Docket Number:	14-AAER-02
Project Title:	Computer, Computer Monitors, and Electronic Displays
TN #:	211620
Document Title:	ITI/TechNet Comments on Displays
Description:	N/A
Filer:	System
Organization:	ITI/TechNet
Submitter Role:	Public
Submission Date:	5/23/2016 5:21:09 PM
Docketed Date:	5/24/2016

CEC Final Draft Staff Report for Displays (Docket #14-AAER-2)

ITI/TechNet Comments on CEC Staff Report

ES6.0 vs ES 7.0 vs CEC

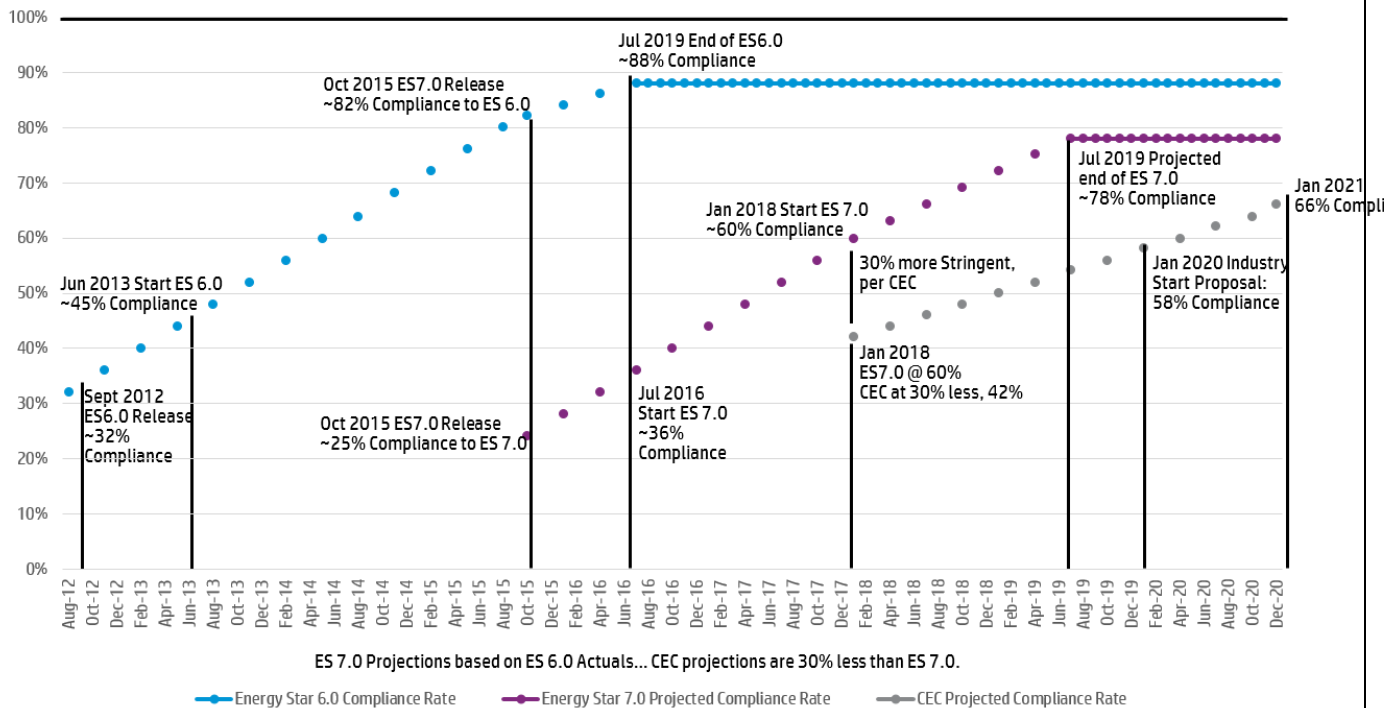
For Monitors 20” and lower...

Projected monitor sales for these sizes show declines thru 2024. 17” Size will likely not be sold beyond 2020 and 18.5” will likely not be sold in significant volume beyond 2022.

Proposal is to split the first segmentation into two:

- Keep 17” and under Displays out of scope
- Significantly relax the On Mode limit for the 17” to 20” Display segment
- Relax the On Mode limit for the 20” to 23” Display segment
